**DEFENSE NUCLEAR FACILITIES
SAFETY BOARD**

Staff Report

August 16, 2019

Safety Basis for the Plutonium Facility at Los Alamos National Laboratory

Figure B-1. ICRP-71 Annexe D.2 Recommended Assignments against Park’s Data

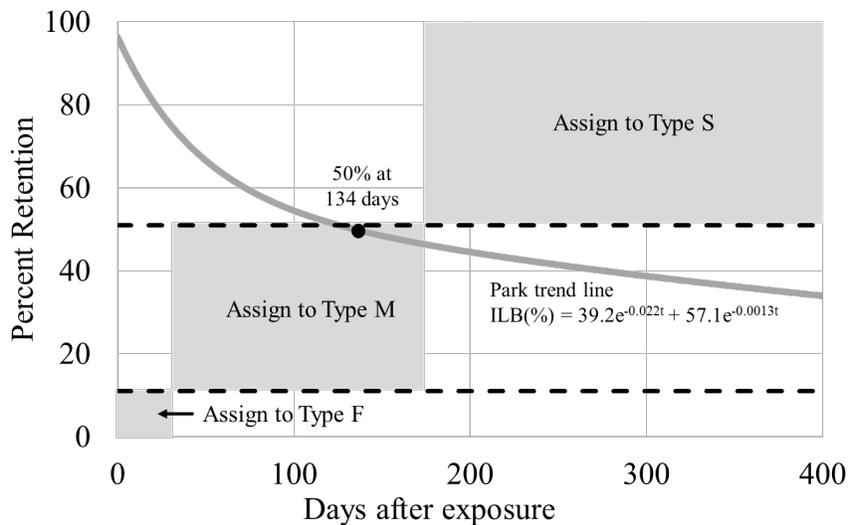
The ESS references a study by Park [23] as the basis for establishing the 800°C threshold for applying the intermediate solubility class. The Park report presents measured lung retention as a function of time for dogs that were exposed to ²³⁸PuO₂ through inhalation. Based on their review of the Park data, LANL safety basis personnel concluded that the ²³⁸PuO₂ material used in the experiments (i.e., heated to 800°C for two hours) exhibited behavior consistent with Type S material. They based this conclusion on a determination—without documenting their rationale—that the Park data demonstrated a 50 percent retention time of 400 days.

Annexe D of ICRP-71 provides guidance for assigning lung clearance types to radionuclides based on experimental data. Figure D.2 in ICRP-71 establishes regions for assigning lung clearance types to experimental data of lung retention behavior. Figure B-1 below overlays Park’s fit of the experimental data (initial lung burden [ILB]) with Figure D.2 of

ICRP-71. The resulting figure with the corresponding trend line demonstrates that 50 percent lung retention occurs at 134 days, which the ICRP guidance indicates is consistent with Type M material.
